1 Introduction

- 1.2 This Note seeks to address the comments made by AECOM acting on behalf of National Highways (NH), provided by email from Patrick Thomas on 28th March (attached in Appendix A), in relation to TT's M42 Jn10 TRANSYT Note, dated 8th March 2024, and the v7 TRANSYT model files also supplied on 8th March.

Image 3: AECOM Screenshot of the A5 Eastbound Exit at Junction 10 (AM Peak)

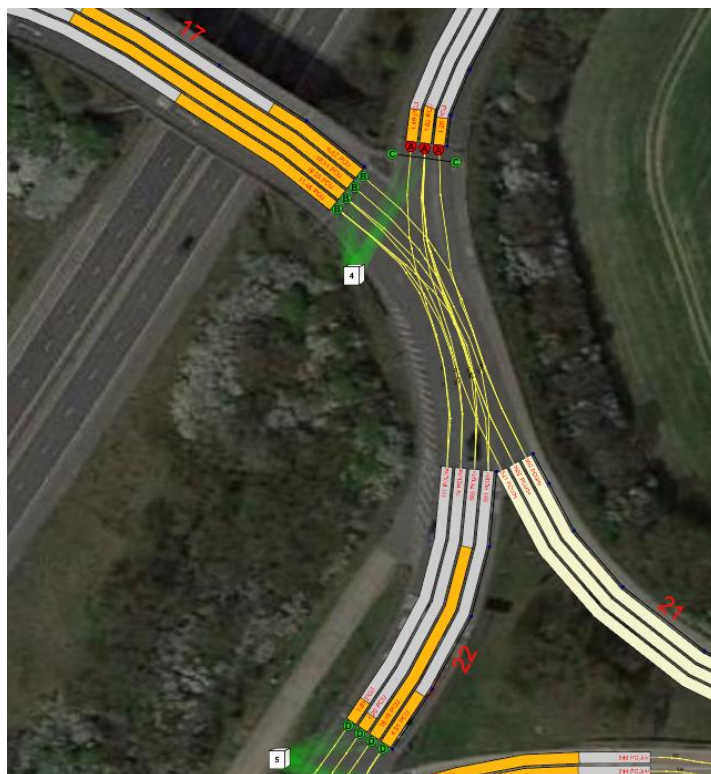
3.9 **NH/ AECOM comment summary:** *With the increased blocking back to Link 22/2, the results show that the queue on this Link will increase from 6pcu (35m) to 17pcu (98m), this is a potential concern. The distance back to the A5 Eastbound exit from the roundabout on this lane is approximately 90m, and it is likely that this queue would impede traffic leaving the roundabout from the northern overbridge (Links 17/1, 17/2, 17/3 and 17/4), which the model currently does not fully account for. As the queues reported are Mean-Max Queues, they are an average of the maximum queues each cycle, so in reality the quoted queue length will be exceeded at times.*

3.10 Image 3 below was included in the AECOM email of 28th March illustrating the comment raised.

3.11 As suggested by AECOM additional lane connectors have been included to enable traffic to switch lanes to join shorter queues. In addition, the traffic flows between the lanes on the approaches and circulatory carriageway have been adjusted to improve the flow balance.

3.12 Image 4 below shows the revised TRANSYT queues and resultant queues summarised further below. Briefly, this shows the circulatory queue on Link 22/2 is reduced from 17pcu to 6pcu (a reduction of 11pcu) and much less likely to block back and affect traffic leaving the roundabout from the northern overbridge (Links 17/1, 17/2, 17/3 and 17/4). The queue on lane 22/1 has increased from 5pcu to 8pcu, and is some 46m in length. This queue does not extend back to the A5 eastbound exit.

Image 5: AECOM Screenshot of the Northern Overbridge and Exit to the M42 Northbound On-Slip (AM Peak)

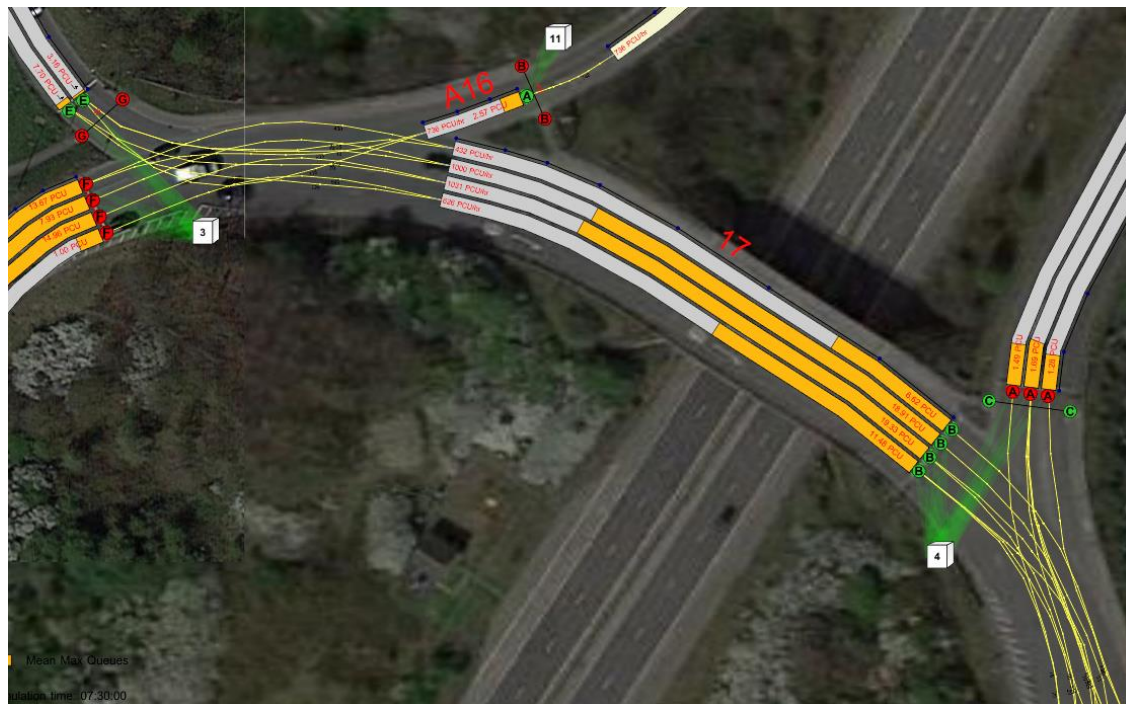
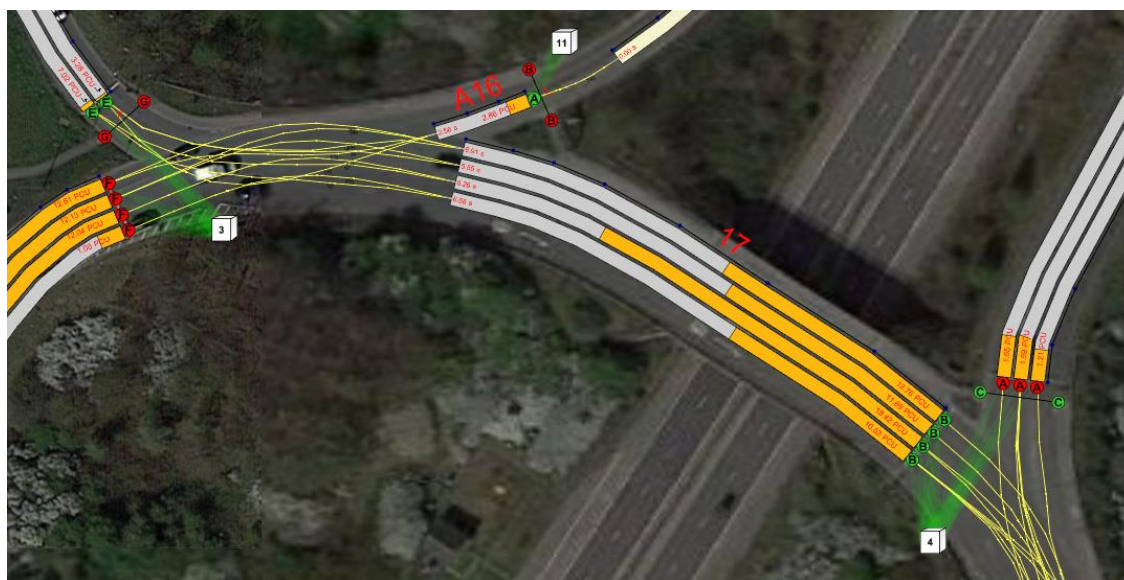
3.14 **NH/ AECOM comment summary:** *As Links 17/1, 17/2 and 17/3 (the three lanes going to the A5 Eastbound exit) do not take into effect the blocking back on Link 22/2, the modelled queues will be greater than predicted currently in the model outputs. Whilst the queue on Lane 3 is predicted to fall from 21 to 19pcu (109m), the queue on lane 2 is predicted to increase from 16 to 19pcu (109m) with the distance back to the M42 Northbound On-slip on this lane being approximately 98m. Of the three northern overbridge lanes that go the A5 Eastbound exit, TRANSYT sees an imbalance with half the flows on lane 1 compared to lanes 2 and 3. Half of the flow on lane 3 stays on the roundabout (going to Link 22/1), but it would be fair to assume that there would be a more equitable split across the three lanes (currently 432 in lane 1, 1000 in lane 2 and 1031 in lane 3). TRANSYT is quite limited in its ability for vehicles to change lane on Links (unless set up with multiple connectors), which is likely to happen in reality and is replicated in software such as VISSIM. With a more equitable lane split, it is less likely queues will block back to the M42 Northbound on-slip. Can the applicant see if they can resolve this matter with a model amendment.*

3.15 Image 5 below was included in the AECOM email of 28th March illustrating the comment raised.

- 3.16 As suggested by AECOM additional lane connectors have been included to enable traffic to switch lanes to join shorter queues. In addition, the traffic flows between the lanes on the approaches and circulatory carriageway have been adjusted to improve the flow balance.
- 3.17 Image 6 below shows the revised TRANSYT queues. Briefly, this shows the circulatory queue on Link 17/2 is reduced by 5pcu to 12pcu (69m) which does not block back to the M42 northbound on-slip. The queue on Link 17/3 is 18pcu, a reduction of 1pcu. This queue extends to the M42 northbound exit, but does not impede M42 bound traffic as this is the nearside two lanes (Links 15/1 and 15/2 are allocated for Green Lane and M42 North).

Image 6: Revised Modelling, Northern Overbridge and Exit to the M42 Northbound On-Slip (AM Peak)

3.19 The modelling results reflect these changes and now show the queue on Link 17/2 is 13pcu (75m) reduced from 19pcu, which is also 3pcu shorter than the No Development queue. The queue on Link 17/3 is 18pcu (104m), 3pcu shorter than the No Development queue of 21pcu. With the more equitable lane split and reduction in queues the queue in 17/3 does extend back to the M42 northbound exit, but does not block the exit because traffic for M42 north is located in the adjoining 2 nearside lanes (Links 15/1 and 15/2). As noted elsewhere, the

Image 7: AECOM Screenshot of the A5 Southern Overbridge at Junction 10 (PM Peak)

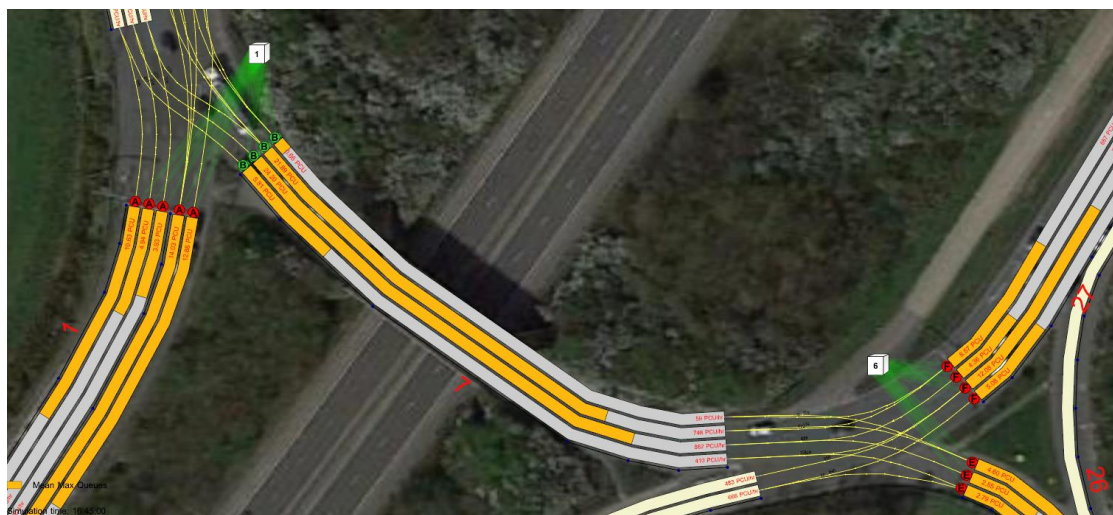
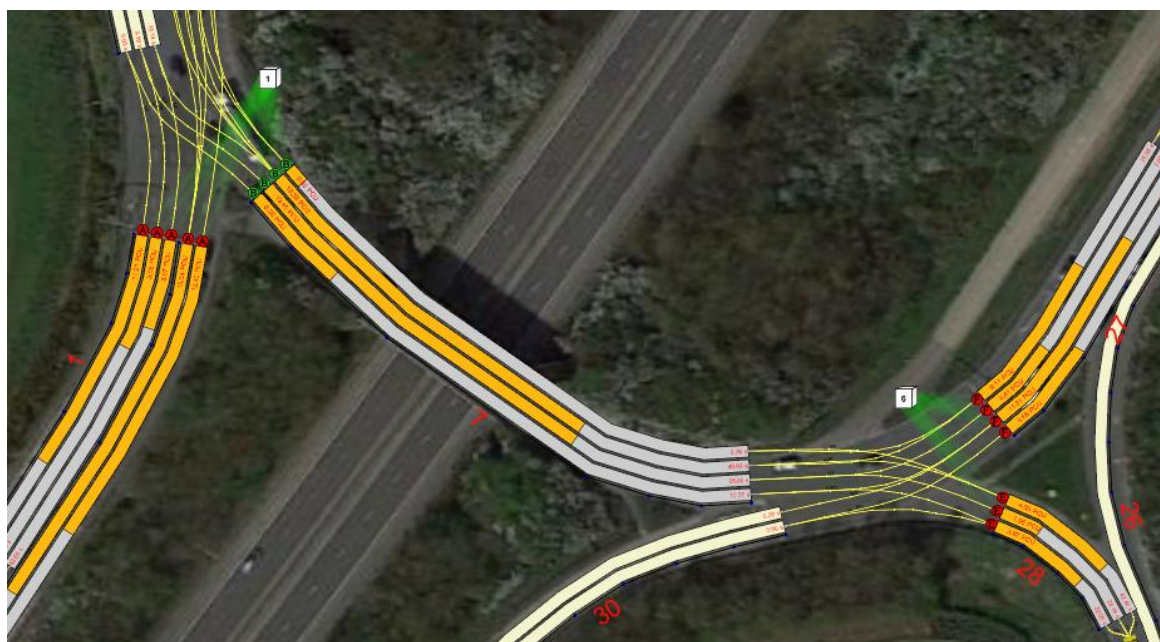
4.1 **NH/ AECOM comment summary:** *In the PM Peak, the main area of concern is on the southern circulatory (Link 7). Lane 2 sees the queue increase from 20 to 25pcu (144m), whilst lane 3 sees the queue increase from 18 to 22pcu (127m). On both lanes, the distance back to the M42 southbound on-slip is approximately 120m. Such a queue wouldn't block traffic getting onto the M42, but may stop traffic getting onto the roundabout from Trinity Road, which isn't a material concern to National Highways. Lanes 1, 2 and 3 on the southern overbridge all go to the A5 westbound exit (lane 3 is shared with traffic remaining on the roundabout). As with the issue highlighted on the northern overbridge in the AM Peak, lane 1 sees half of the flow exhibited on lanes 2 and 3 (410 on lane 1, 862 on lane 2 and 748 on lane 3). It would be fair to assume that in reality some of the lane 2 and lane 3 flows heading to the A5 will move over to lane 1 to create a fairer balance of flows and therefore reducing the queue lengths on lanes 2*

and 3. TRANSYT is limited in its ability for vehicles to change lanes whilst on the lanes, unlike as it would happen in a more sophisticated VISSIM model. An amended model with additional connectors may be able to resolve this matter.

4.2 Image 7 below was included in the AECOM email of 28th March illustrating the comment raised.

4.3 As suggested by AECOM additional lane connectors have been included to enable traffic to switch lanes to join shorter queues. In addition, the traffic flows between the lanes on the approaches and circulatory carriageway have been adjusted to improve the flow balance.

4.4 Image 8 below shows the revised TRANSYT queues. Briefly, this shows the circulatory queue on Links 7/2 and 7/3 are now shorter (reduction of 5pcu to 20pcu, and a reduction of 3pcu to 19pcu in Links 7/2 and 7/3 respectively) and are less likely to block back and affect traffic exiting to the M42 southbound on-slip. The model is set up so that if there are short-lived queues which do block back, then the consequential upstream effects are modelled.

Image 8: Revised Modelling, Southern Overbridge at Junction 10 (PM Peak)

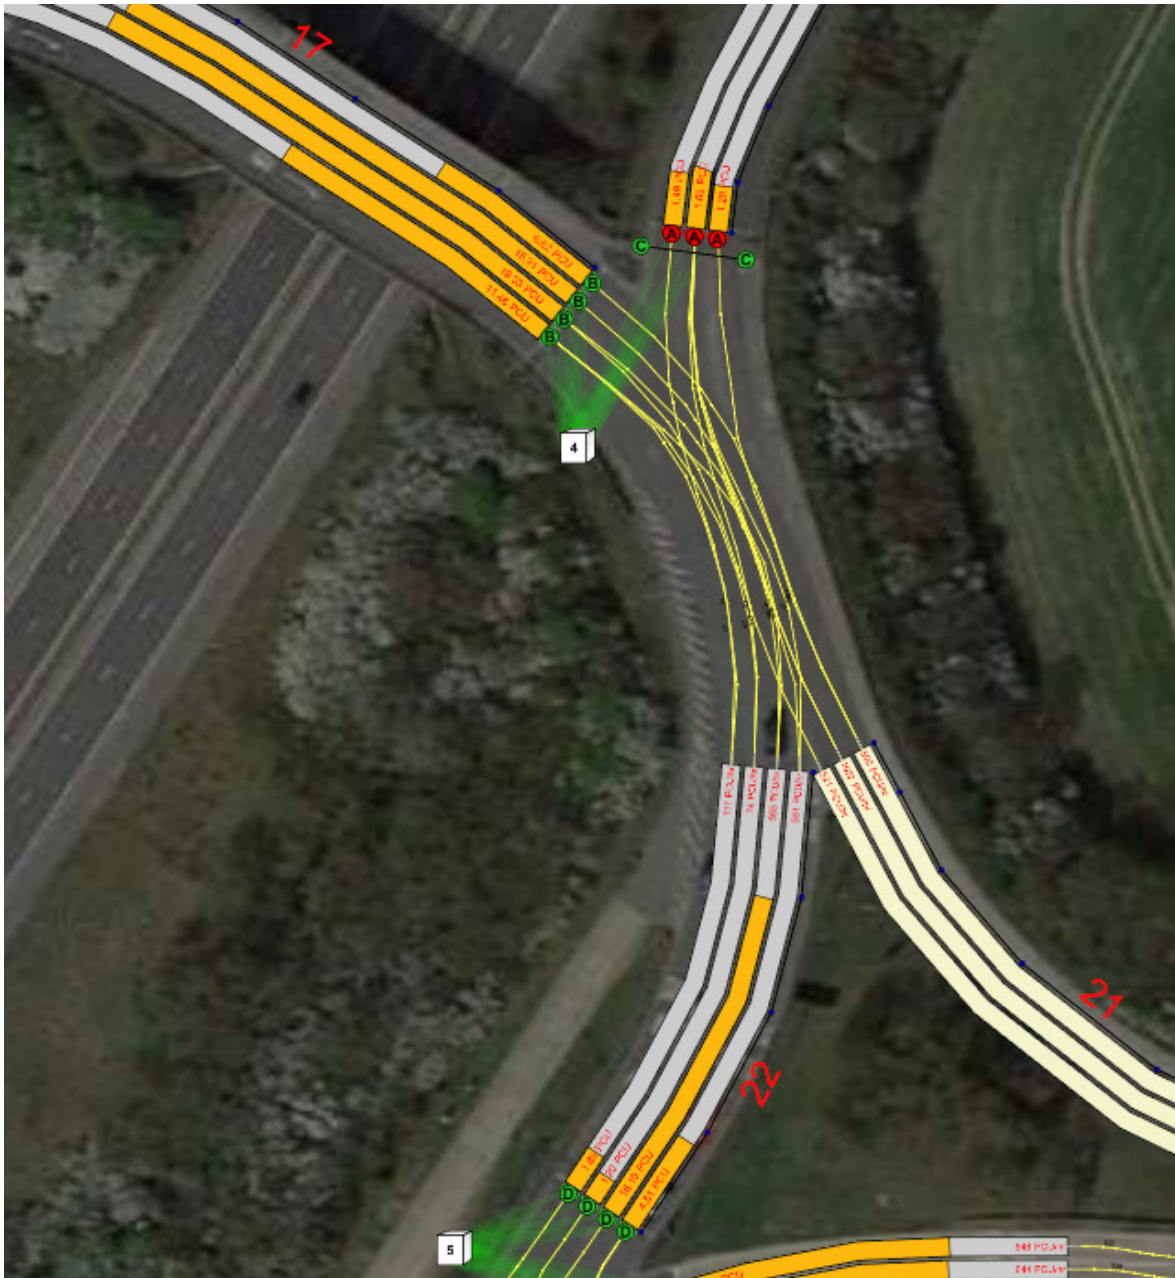
The queue on the circulatory lane next to the Trinity Road approach (link 27/2) sees a minor increase (15pcu to 16pcu or 92m). This queue will stretch back to the A5 Westbound entry. Although this blocking back will be taken into effect on Links 23/2 and 22/2 (the two lanes that feed it), the blocking back will also affect traffic trying to enter the roundabout on Links 23/3 and 23/4 (the offside two lanes of the A5

Westbound approach). This effect is not currently modelled in TRANSYT, so the queuing on Links 23/3 and 23/4 will be higher than predicted.

However, in this instance increased queues on Links 23/3 and 23/4 are likely to be accommodated on the existing highway due to the distance back to proposed site access junction. They could increase to levels predicted on the nearside lane, which the TRANSYT animation mode has indicated would stretch back to the access junction on occasions even though the Mean-Max Queue is shown not to stretch back this far. The introduction of a yellow box or similar could potentially mitigate any issues at the access junction or queueing would be contained within the site if it was unable to get out onto the A5. This approach is of a concern but our feeling is that it is likely not to be a material impact, although the model should be updated to better reflect the true impact in terms of queues for review.

With the increased blocking back to Link 22/2, the results show that the queue on this link will increase from 6pcu (35m) to 17pcu (98m), this is a potential concern. The distance back to the A5 Eastbound exit from the roundabout on this lane is approximately 90m, and it is likely that this queue would impede traffic leaving the roundabout from the northern overbridge (Links 17/1, 17/2, 17/3 and 17/4), which the model currently does not fully account for. As the queues reported are Mean-Max Queues, they are an average of the maximum queues each cycle, so in reality the quoted queue length will be exceeded at times.

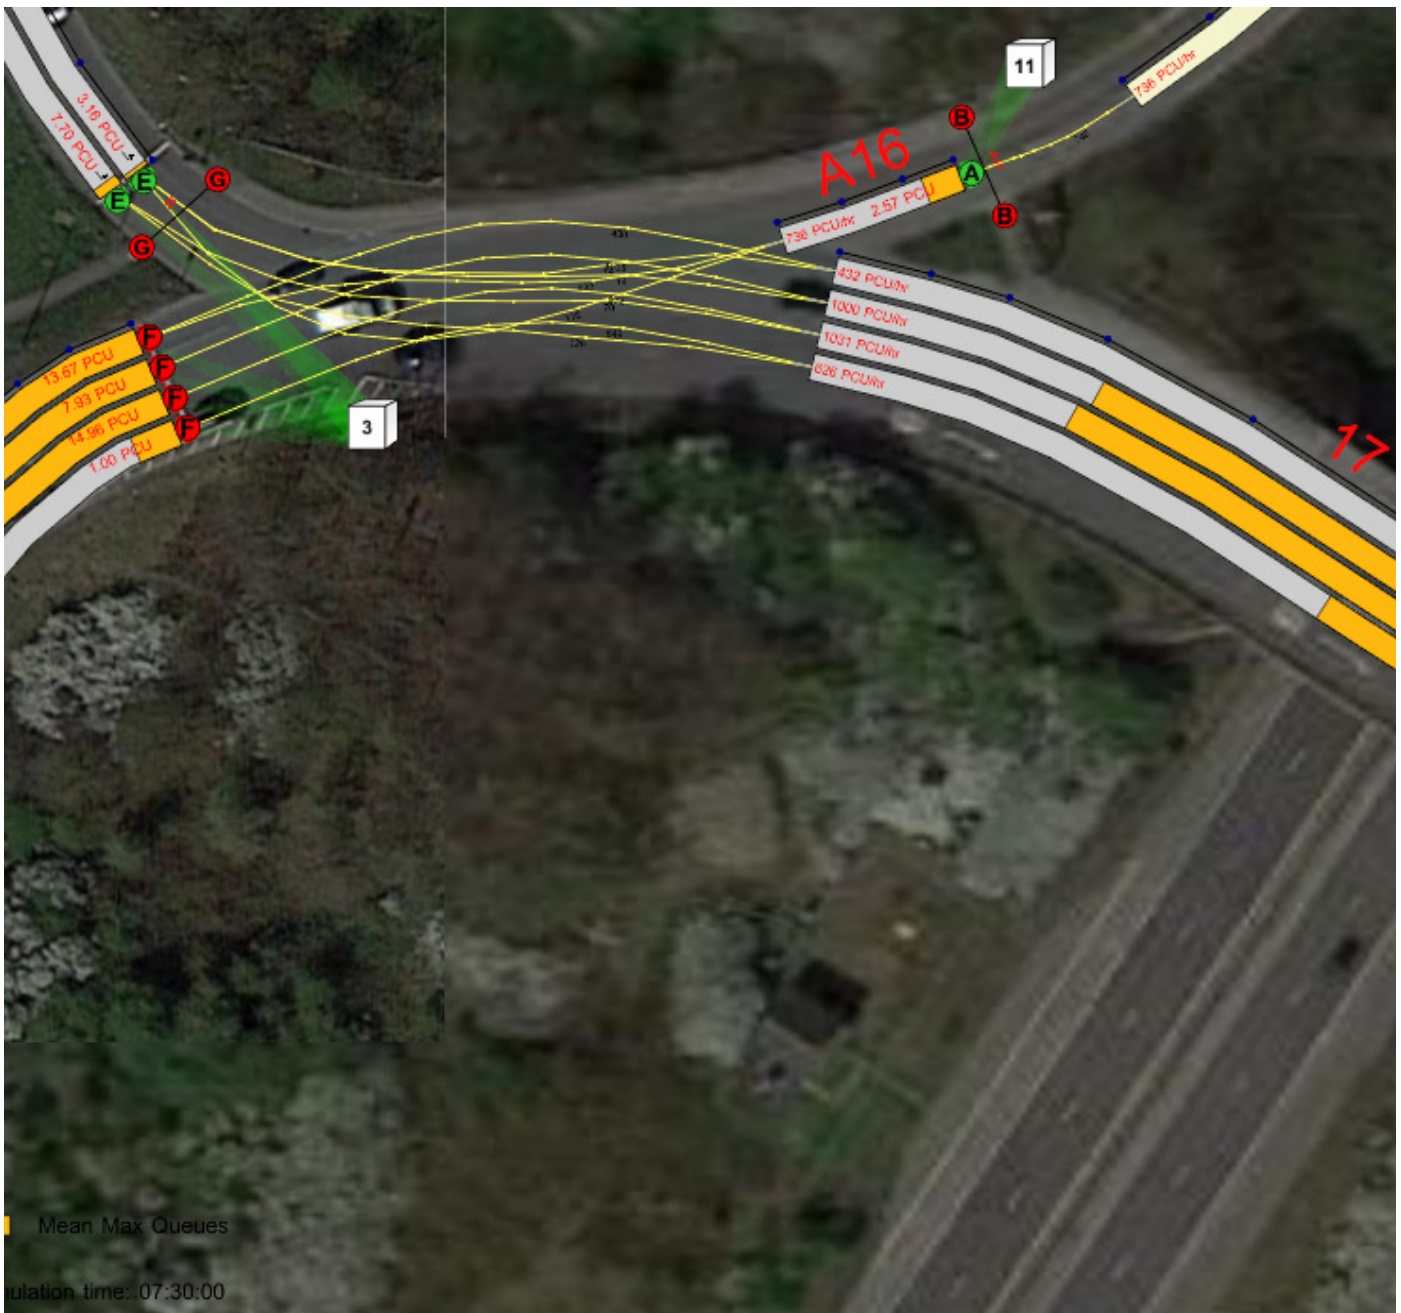
As Links 17/1, 17/2 and 17/3 (the three lanes going to the A5 Eastbound exit) do not take into effect the blocking back on Link 22/2, the modelled queues will be greater than predicted currently in the model outputs. Whilst the queue on Lane 3 is predicted to fall from 21 to 19pcu (109m), the queue on lane 2 is predicted to increase from 16 to 19pcu (109m) with the distance back to the M42 Northbound On-slip on this lane being approximately 98m.

Of the three northern overbridge lanes that go the A5 Eastbound exit, TRANSYT sees an imbalance with half the flows on lane 1 compared to lanes 2 and 3. Half of the flow on lane 3 stays on the roundabout (going to Link 22/1), but it would be fair to assume that there would be a more equitable split across the three lanes (currently 432 in lane 1, 1000 in lane 2 and 1031 in lane 3). TRANSYT is quite limited in its ability for vehicles to change lane on links (unless set up with multiple connectors), which is likely to happen in reality and is replicated in software such as VISSIM. With a more equitable lane split, it is less likely queues will block back to the M42 Northbound on-slip. Can the applicant see if they can resolve this matter with a model amendment.

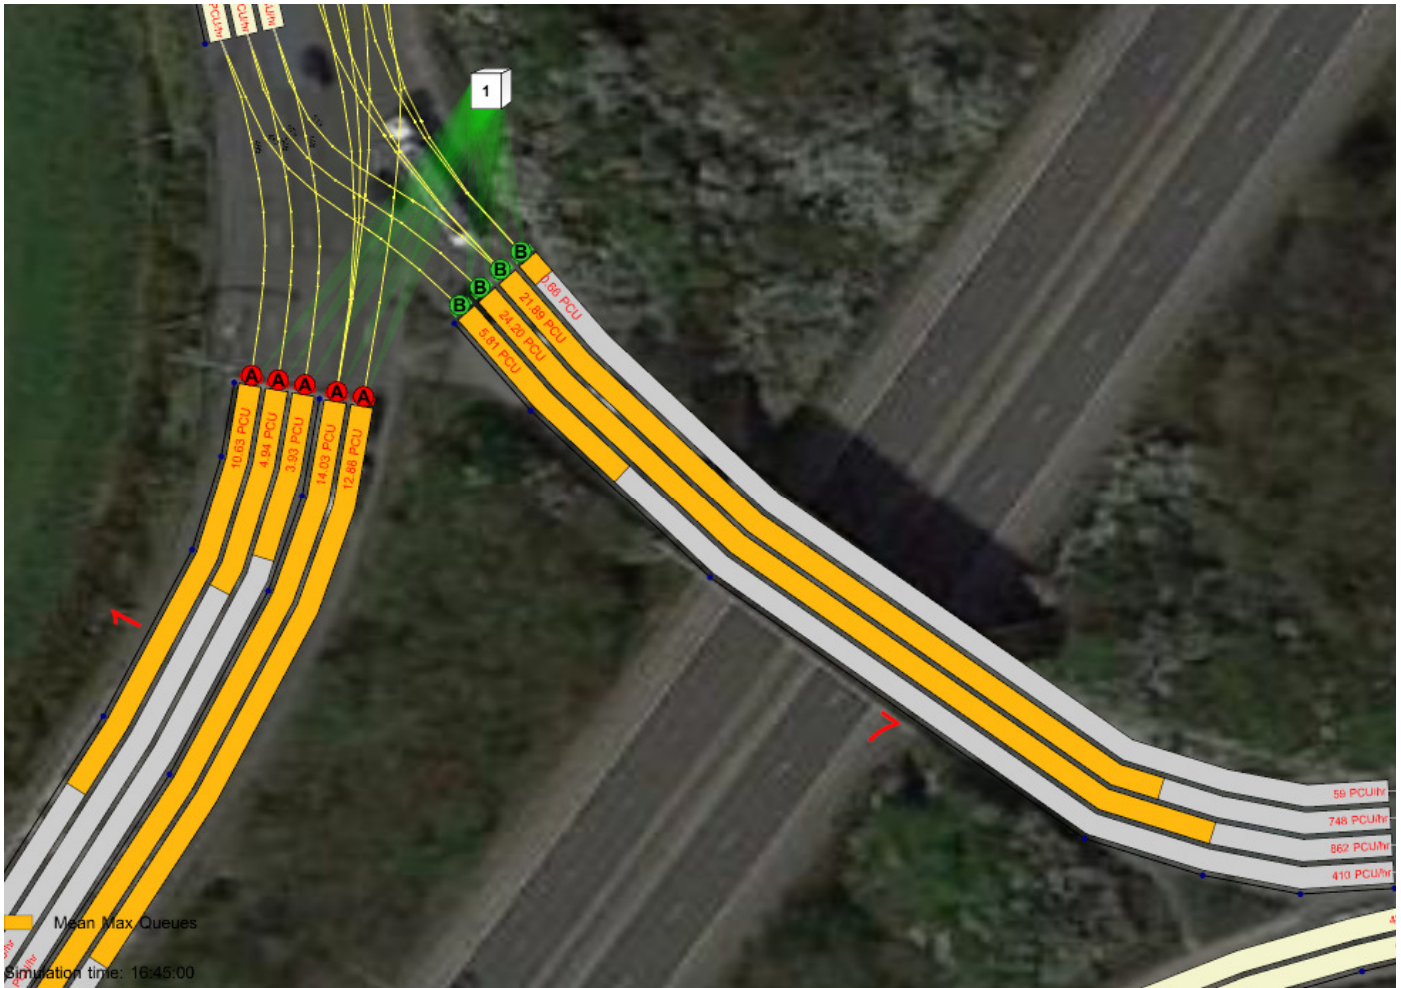
In the PM Peak, the main area of concern is on the southern circulatory (link 7). Lane 2 sees the queue increase from 20 to 25pcu (144m), whilst lane 3 sees the queue increase from 18 to 22pcu (127m). On both lanes, the distance back to the M42 southbound on-slip is approximately 120m. Such a queue wouldn't block traffic getting onto the M42, but may stop traffic getting onto the roundabout from Trinity Road, which isn't a material concern to National Highways.

Lanes 1, 2 and 3 on the southern overbridge all go to the A5 westbound exit (lane 3 is shared with traffic remaining on the roundabout). As with the issue highlighted on the northern overbridge in the AM Peak, lane 1 sees half of the flow exhibited on lanes 2 and 3 (410 on lane 1, 862 on lane 2 and 748 on lane 3). It would be fair to assume that in reality some of the lane 2 and lane 3 flows heading to the A5 will move over to lane 1 to create a fairer balance of flows and therefore reducing the queue lengths on lanes 2 and 3. TRANSYT is limited in its ability for vehicles to change lanes whilst on the lanes, unlike as it would happen in a more sophisticated VISSIM model. An amended model with additional connectors may be able to resolve this matter.
